Access Compliance Report

Public Rights-of-Way

(Curb Ramps)

Intersection ID: 4679	Main Street: HERITAGE_POINTE_RD	Cross Street: US_29_ACCESS_RD	Location:	N
ADA ID: B4299BAB6623	Ramp Type: Perp	Initial Pass/Fail: Fail	Overall Compliance: No	Severity Score: 46.25
Codes/Mitigation Info/Possible Solution		Field Measurements/Component Compliance

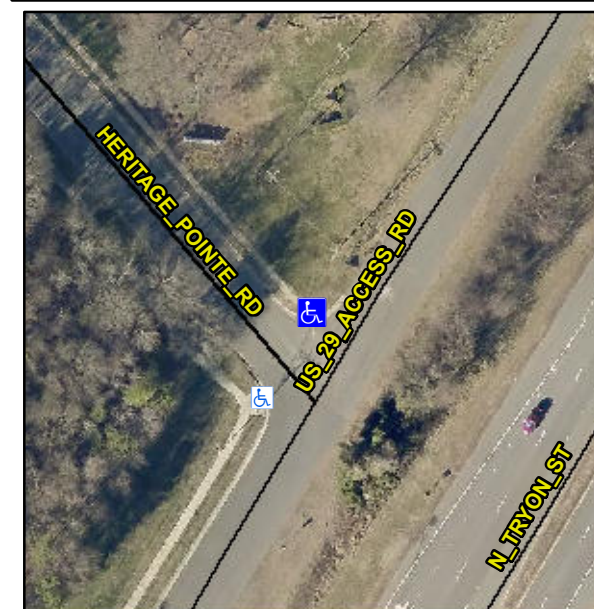
R304.5.1, R304.2.2, R304.5.3

Compliance	Description	Data	Compliance	Description	Data
N/A	Ramp Length (in)	103.0	No	Ramp Slope (%)	20.0
No	Ramp Width (in)	36.0	No	Ramp XSlope (%)	6.4
N/A	Flare Type LT	N/A	N/A	Flare Type RT	N/A
N/A	Flare Slope LT (%)	N/A	N/A	Flare Slope RT (%)	N/A
N/A	Flare Traversable LT?	N/A	N/A	Flare Traversable RT?	N/A
N/A	Landing Length (in)	N/A	N/A	DWS Provided?	N/A
N/A	Landing Width (in)	N/A	N/A	DWS Contrast?	N/A
N/A	Landing Slope (%)	N/A	N/A	DWS Length (in)	N/A
N/A	Landing X Slope (%)	N/A	N/A	DWS Full Width?	N/A
N/A	Landing Curb? (Y/N)	N/A	N/A	DWS Offset (in)	N/A
N/A	Shared Landing?	N/A			
N/A	Gutter Ponding?	N/A	N/A	Gutter Slope (%)	N/A
N/A	Gutter Lip Ht (in)	N/A	N/A	Gutter X Slope (%)	N/A
N/A	Painted X Walk1?	No	N/A	Painted X Walk2?	N/A
	X Walk 1 Direction	To SW		X Walk 2 Direction	N/A
N/A	X Walk 1 Width (in)	N/A	N/A	X Walk 2 Width (in)	N/A
	X Walk 1 Slope (%)	3.1		X Walk 2 Slope (%)	N/A
	X Walk 1 X Slope (%)	1.8		X Walk 2 X Slope (%)	N/A

Remove & Replace Entire Ramp.
